Request for Class II Permissive Change

FCC ID: VG8EAM142AYY Data: 2012-5-13

1. Updated Mainboard as below:

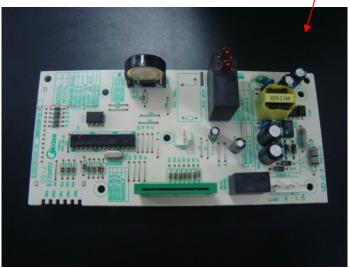
Changed linear power supply to switching power supply

or below switching power supply.

Between of linear power supply and switching power supply have the same specfication of rated output power, changed to the switching power supply, theirs rated output power have not obvious change.

The differences of between this two switching power supply only is PCB layout and components location, anything else are the same.
